FINAL SUPPLEMENTAL  
ENVIRONMENTAL IMPACT STATEMENT  
VOLUME 1 OF 2

CANON, U.S.A., INC.  
TOWN OF HUNTINGTON  
SUFFOLK COUNTY, NEW YORK

JUNE 2009

Figure 4-1. Rendered Master Plan

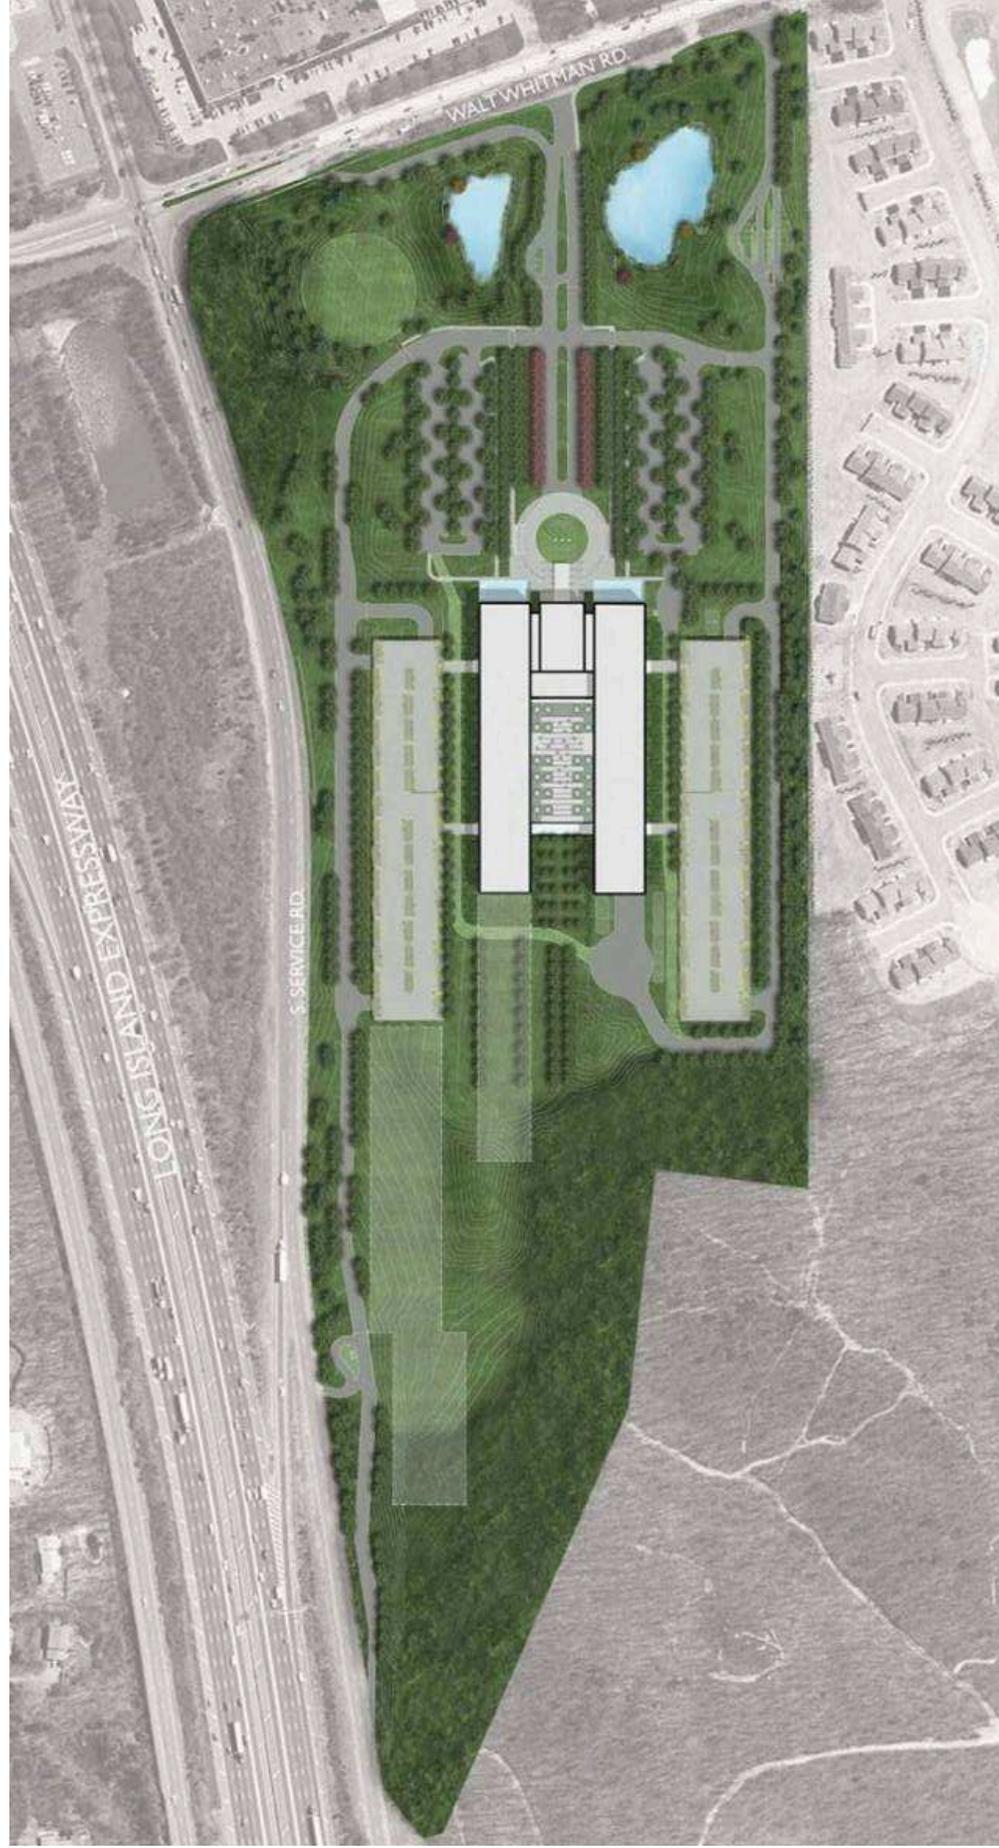
*Figure 1-3 Master Plan shows Phase II, while the Rendered Master Plan Figure 1-4 does not. (Intra-Office Memorandum from Town of Huntington Department of Planning and Environment dated October 14, 2008)*

**Response:** Figure 4-1 has been updated to reflect Phase II.

Figure 4-2. Steep Slope Analysis and Proposed Conservation Easement

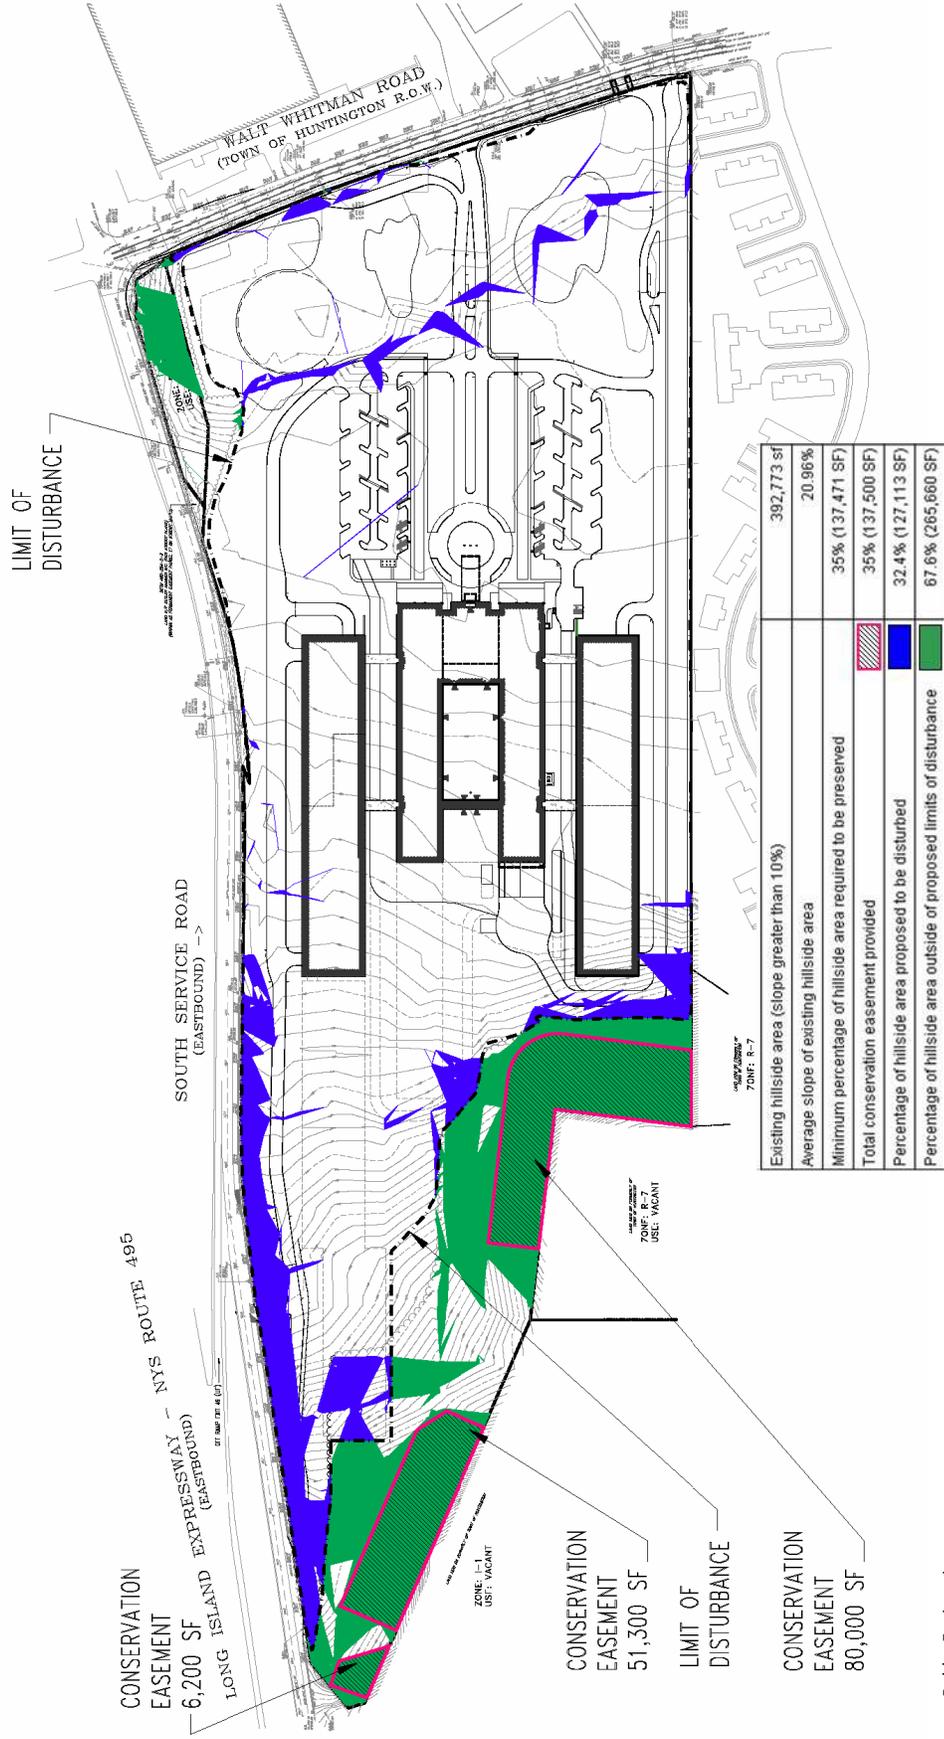
*Indicate that your project will contain the required conservation easement and Covenants and Restrictions to preserve 35% of the existing steep slopes on site. (Intra-Office Memorandum from Town of Huntington Department of Planning and Environment dated October 14, 2008)*

**Response:** Canon shall comply with the Town's steep slope ordinance. Figure 4-2 shows that that steep slopes comprise a total of 392,773 square feet (9.02 acres) with an average slope of 20.96%. Based on the proposed limit of disturbance, more than 60% of the slope land will remain undisturbed. According to the Town ordinance, 35% of the steep slope is required to be preserved in a conservation easement, or in this case, 137,471 square feet (3.16 acres). The proposed location for the easement is shown on Figure 4-2. The easement language will allow for the installation of passive recreational elements including trails, benches and blue-light phone stations within the conservation area.
